**Bulletin #** SR-5K-810

## SERVICE BULLETIN

Ride Name: Cliff Hanger

**Abstract of Issue:** The following is a procedure for upgrading hardware on the pivot pins of the upper and lower hanger blocks.

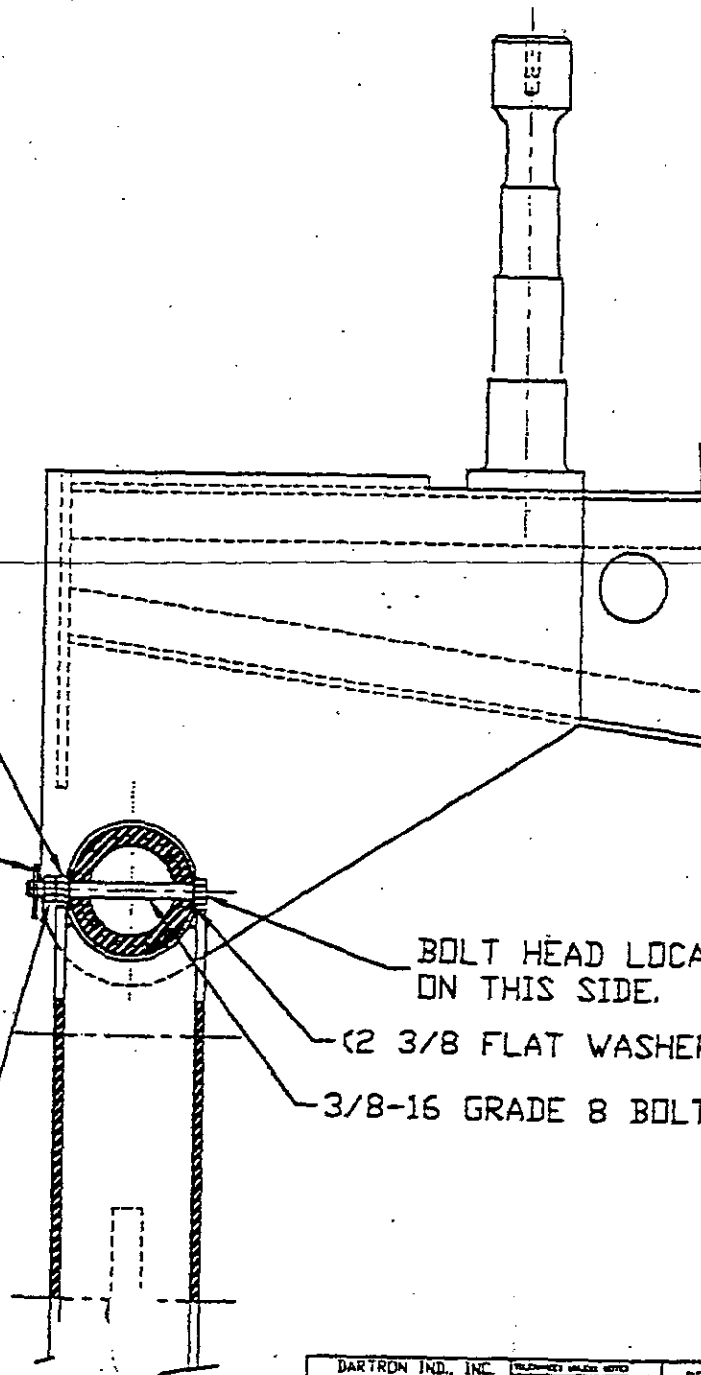
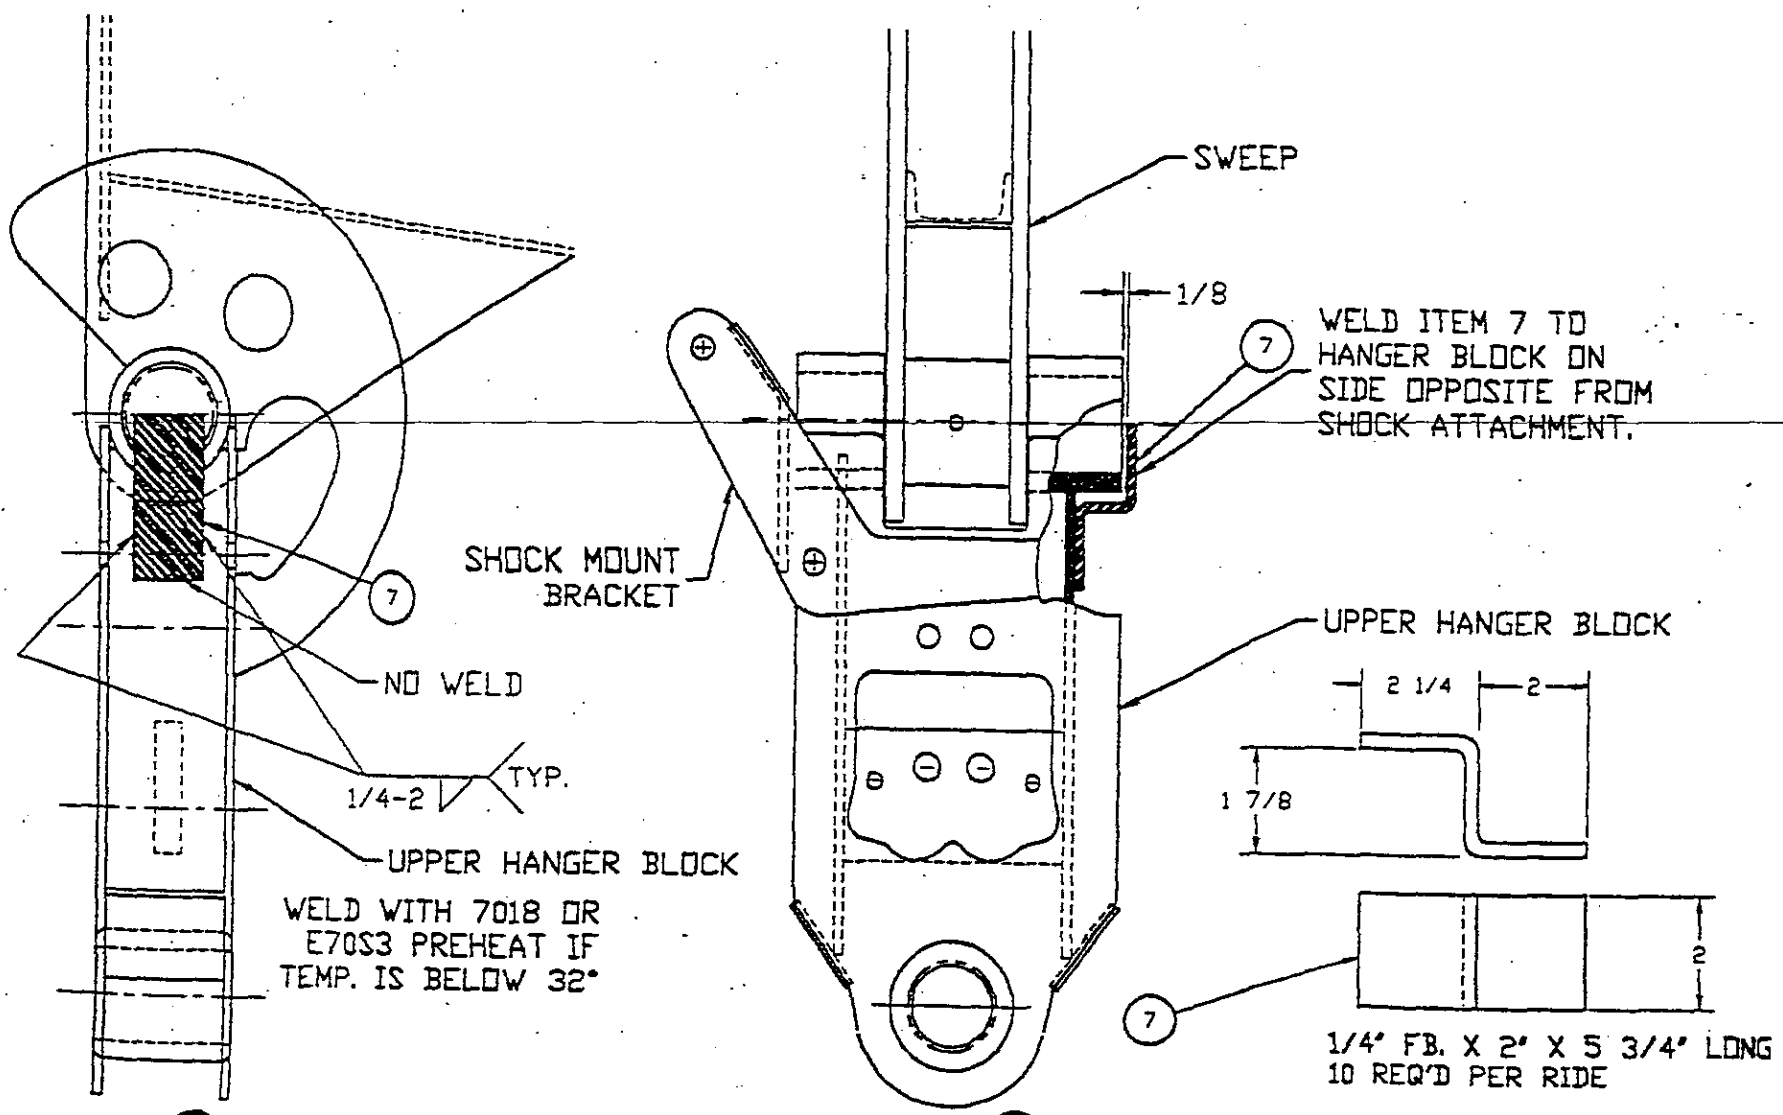
**Sweep and Shaft locating implemented:** Attachment I shows the proper location of the bolt and the proper hardware required to secure the bolt to the shaft. A daily visual inspection of the bolt by the ride operator and ride safety personnel is required. The purpose of the inspection is to insure that the bolt is in position and is fastening hardware is in place and tight.

INSPECT FASTENERS  
& COTTER PINS ON  
A DAILY SCHEDULE  
BEFORE OPERATING  
RIDE.

VISUAL OBSERVATION TO  
BE FROM END OF SWEEP  
NEAR ENOUGH TO CLEARLY  
SEE FASTENERS & RETAINING  
PINS ARE SECURE.

⑦ PIN STOP FOR UPPER HANGER BL IN

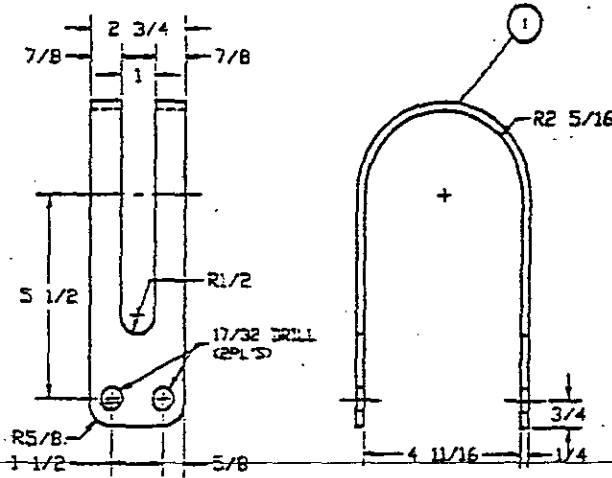
**Shaft Stops:** Attachment II shows the plate that must be welded to the side of the upper hanger block on all Cliff Hangers. With this plate in place the shaft will be retained in position in the upper hanger block even without the bolt properly located.

⑦ 1/4" FB. X 2" X 5 3/4" LONG  
10 REQ'D PER RIDE

SAFETY LOOP FOR UPPER HANGER BLOCK

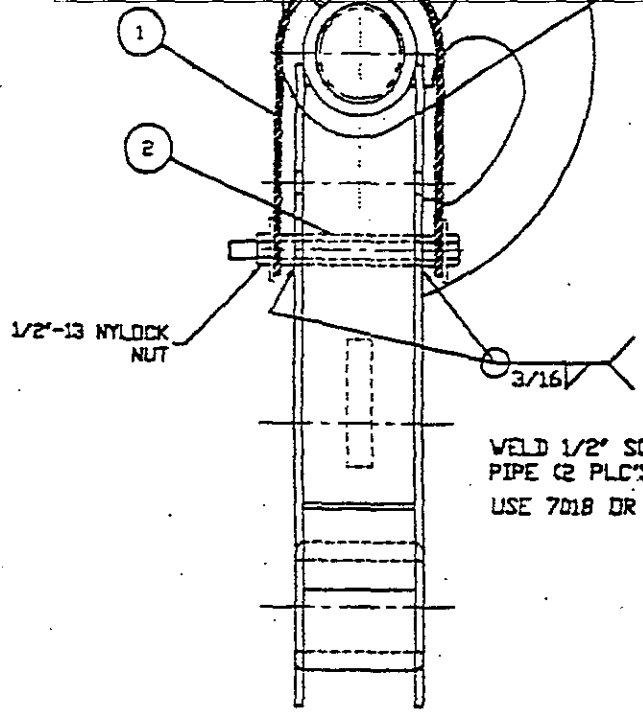
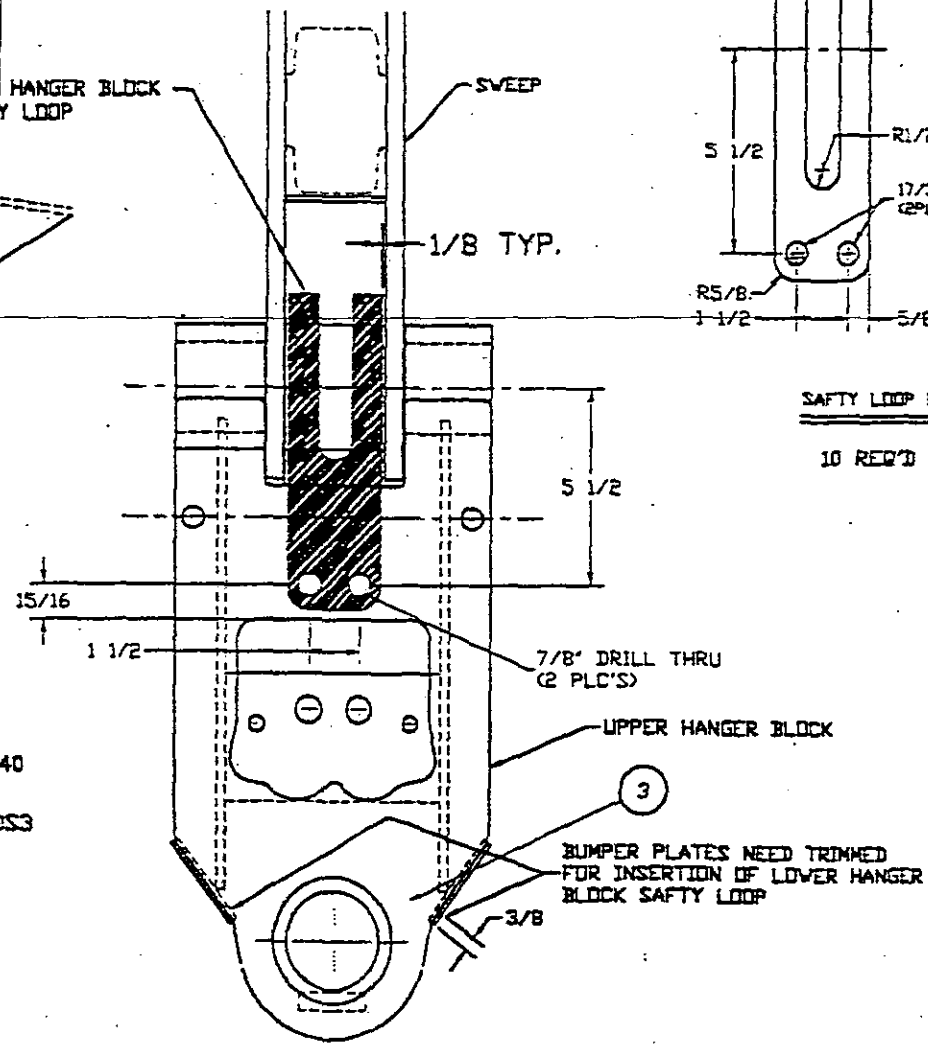
**Upper Restraining Strap:** Attachment III shows the addition of a retaining strap that will loop over the end of the sweep and be bolted to the upper hanger block. In the event of a failure of either the shaft, the upper hanger block bore or the sweep ears a connection will still be maintained between the sweep and the upper hanger block.

MAY NEED TO TRIM  
SWEEP PLATE FOR  
CLEARANCE

10 REQ'D PER RIDE

SAFETY LOOP FOR UPPER HANGER BLOCK

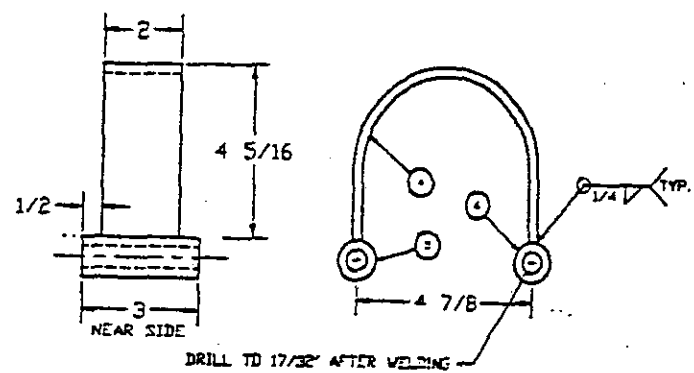
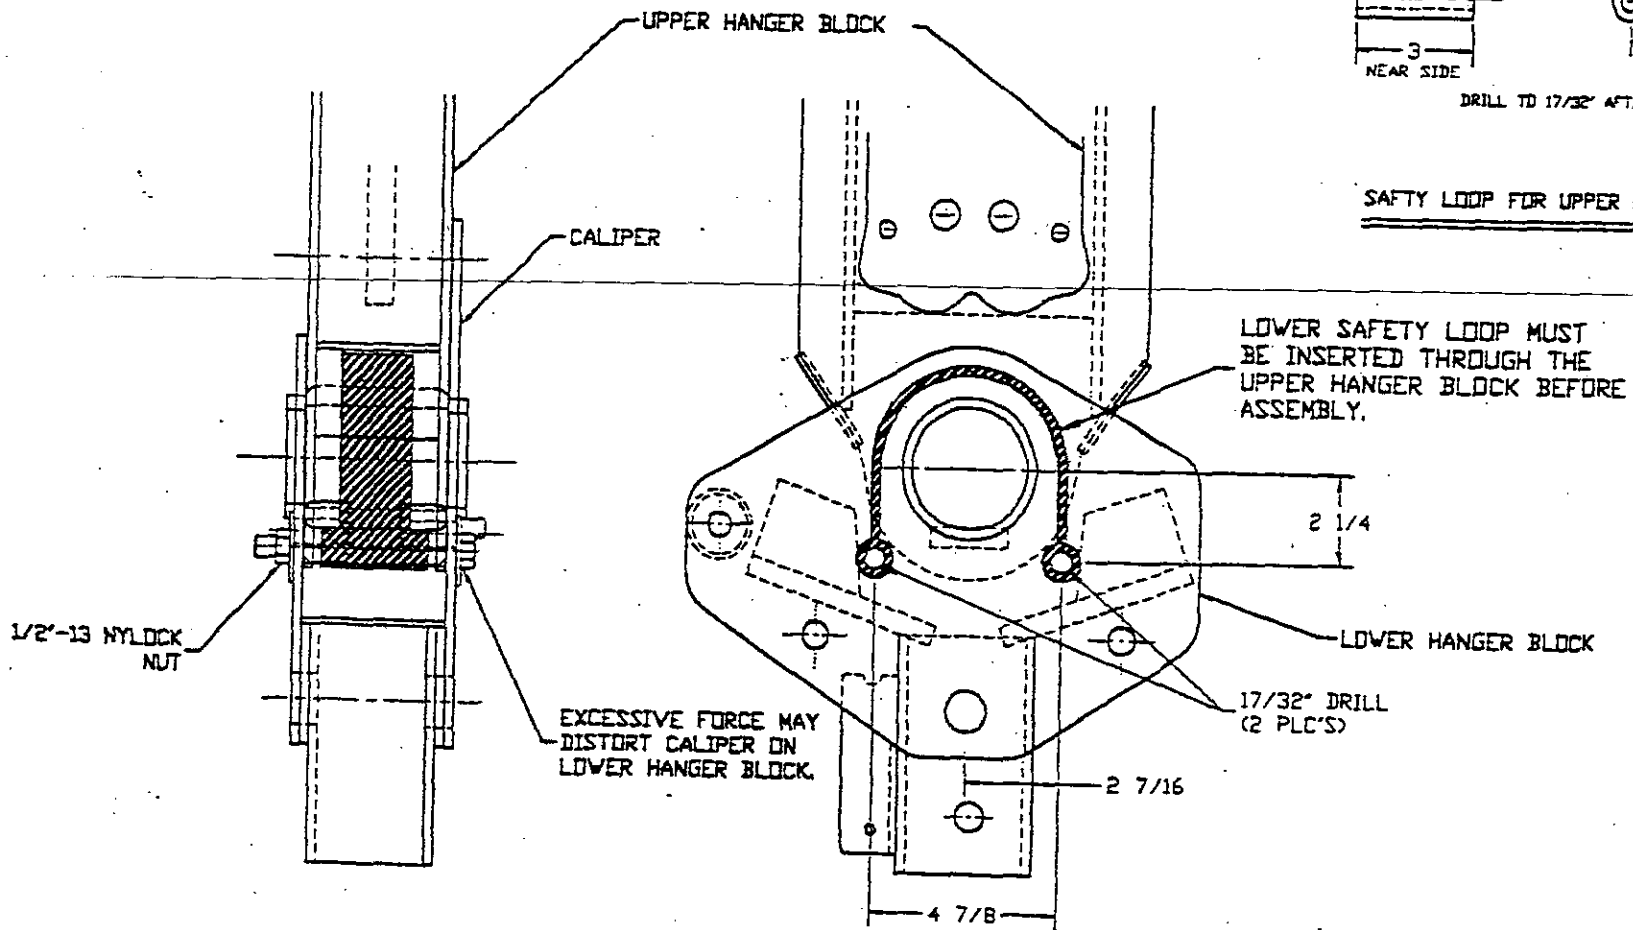
**Lower Hanger Block Retainer:** Attachment IV shows the installation of a retaining ring that will maintain a connection between the upper and the lower hanger blocks in the event of a failure or loss of the upper and lower hanger block retaining shaft.

WELD 1/2" SCH. 40  
PIPE (2 PLC'S)  
USE 7018 DR E70S3

BUMPER PLATES NEED TRIMMED  
FOR INSERTION OF LOWER HANGER  
BLOCK SAFETY LOOP

LOWER SAFETY LOOP MUST BE INSERTED THROUGH THE UPPER HANGER BLOCK BEFORE ASSEMBLY.

17/32" DRILL (2 PLCS)

**DIAGRAM A (LAYOUT PATTERN)**

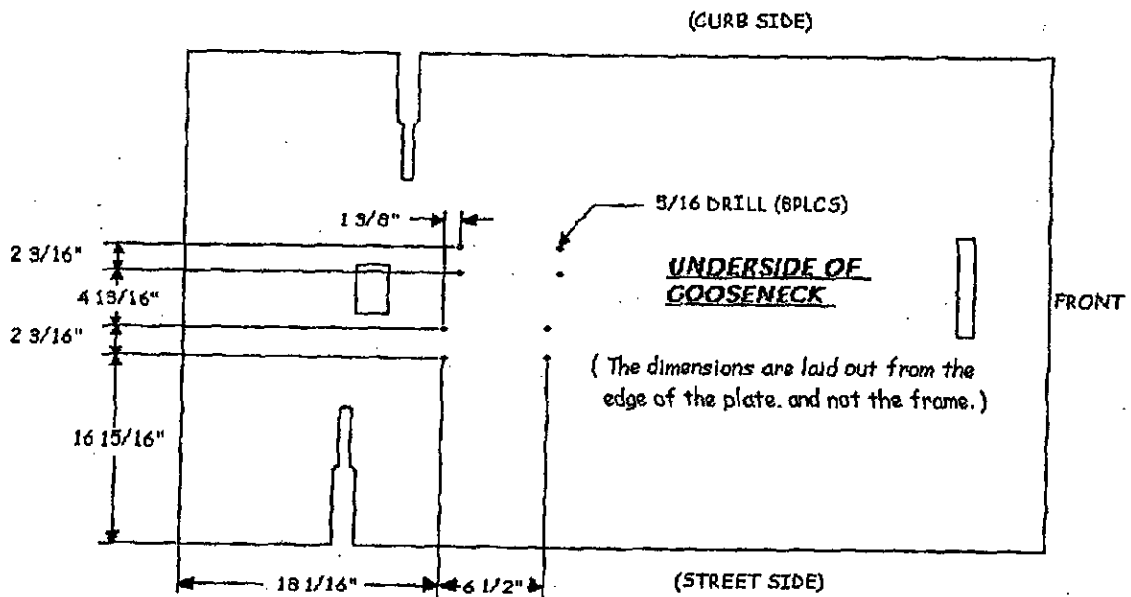
**Step 1:** Drill holes through the gooseneck deck skin using the layout pattern as showed on page 3 Diagram A.

**DIAGRAM B (FLOW DIVIDERS)**

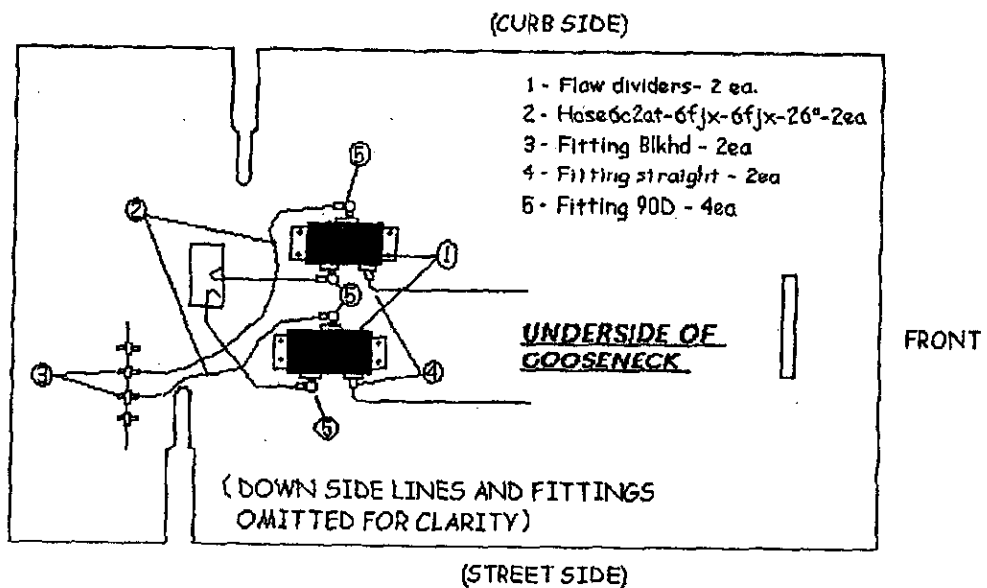
**Step 2:** Install 2 flow dividers with fittings as showed on page 3 Diagram B.

**Step 6:** Extend this bulkhead fitting over to the center port of either one of the flow dividers with one of the hoses from the kit, as shown on page 3 Diagram B.

FLOW DIVIDER  
HYDRAULIC SCHEMATIC

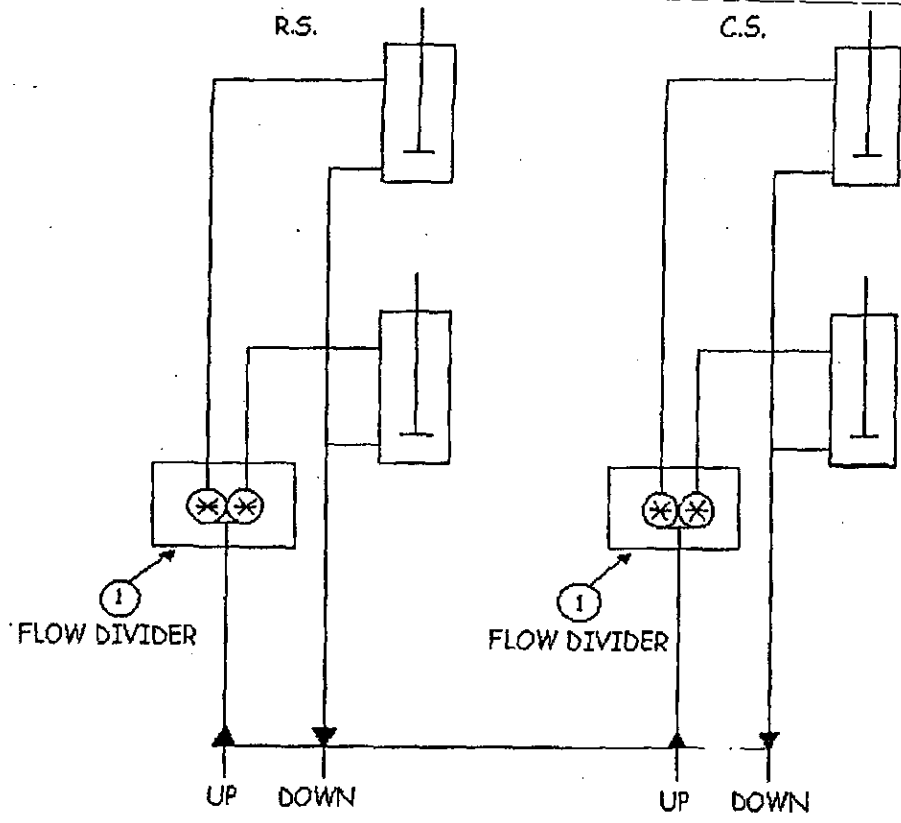
**Step 7:** Hook up the two hoses from the cylinders to the other side of the flow divider. The flow divider now takes the place of the tee that was removed. See schematic on page 4.

**CLIFFHANGER FUSE UPGRADE DIAGRAM.**

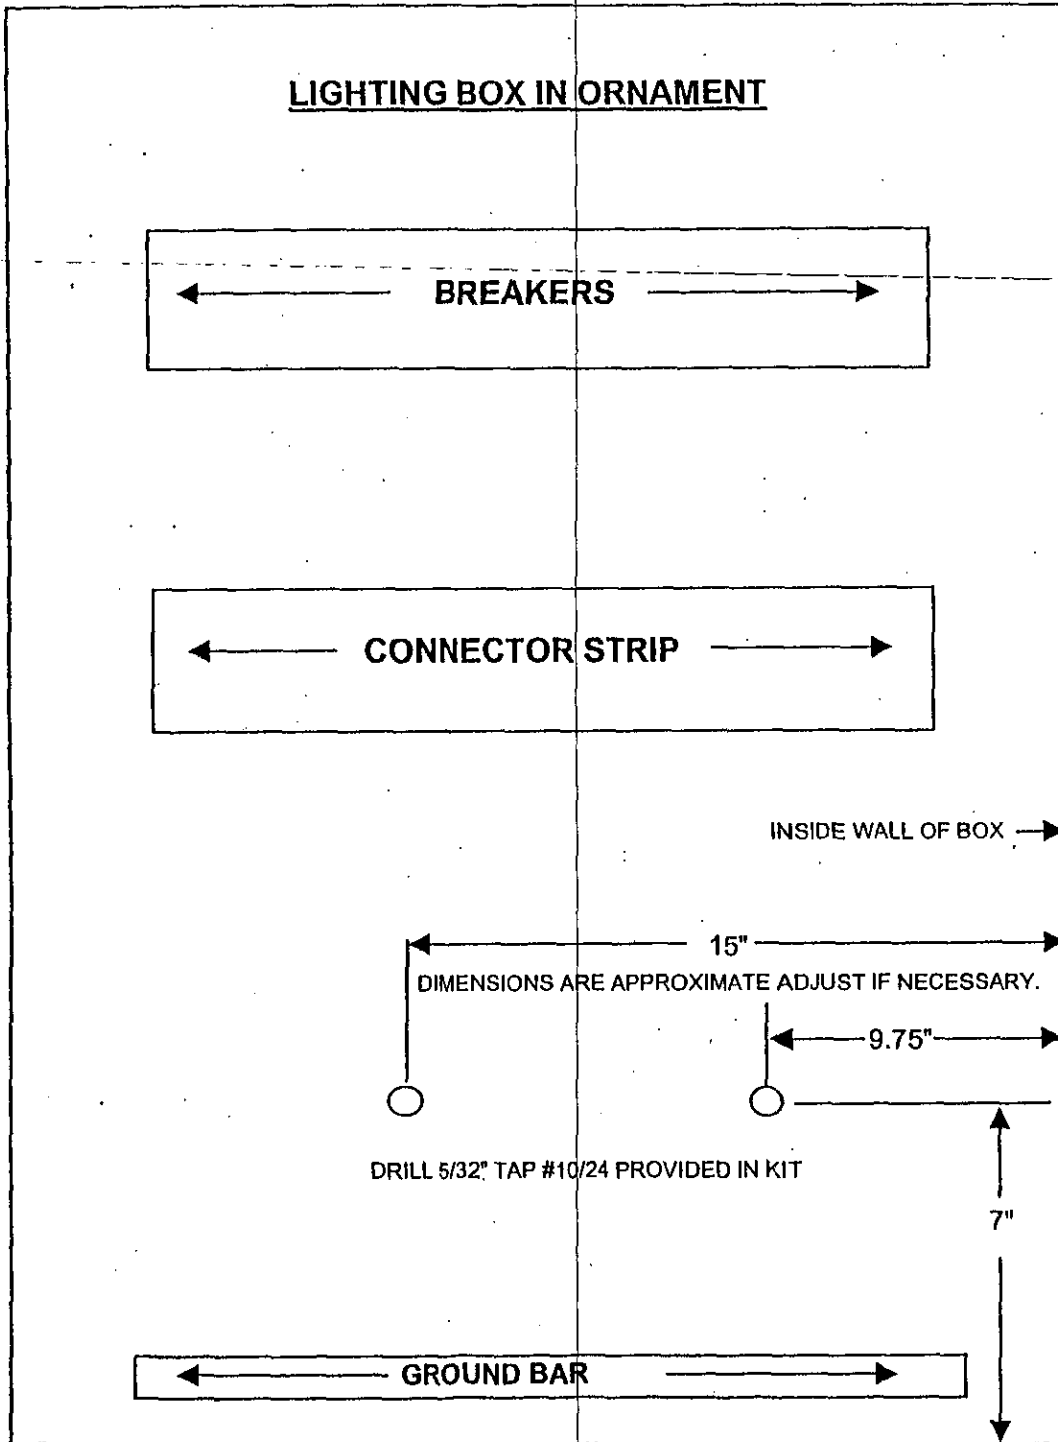
**Start with the six small breakers in the main distribution panel on the trailer.**

1. Remove the gray spacers-1 found on each side of the 24v power supply. They are unnecessary and their removal will provide room on the din-rail for the wider fuse holders.
2. Slide the 24v power supply all the way to the left.
3. Install the string of six fuse blocks labeled 1-6 in place of the circuit breakers, one at a time to avoid mixing up the wires.
4. Install the appropriate placard to the inside of the panel door.

1. Drill and tap two #10/24 holes in the back panel of the lighting box ( see sketch for location. ) These holes should end up in the open section between the barrier strip and ground bar.
2. Mount din-rail with five fuse blocks 19-23 on the 2" long aluminum tubes (stand off spacers) to these holes.
3. Disconnect and remove the breakers labeled 01-02-03-FDS-FDS one at a time and rewire down to the fuse blocks.
4. When finished tie the wire loom back together.
5. Now remove the remaining breakers one at a time and change out to the fuse blocks labeled 1-18. Room for extra width of these fuse blocks has been provided by moving the fuses (19-23) down below.  
Install placard into the door below the heat sink.
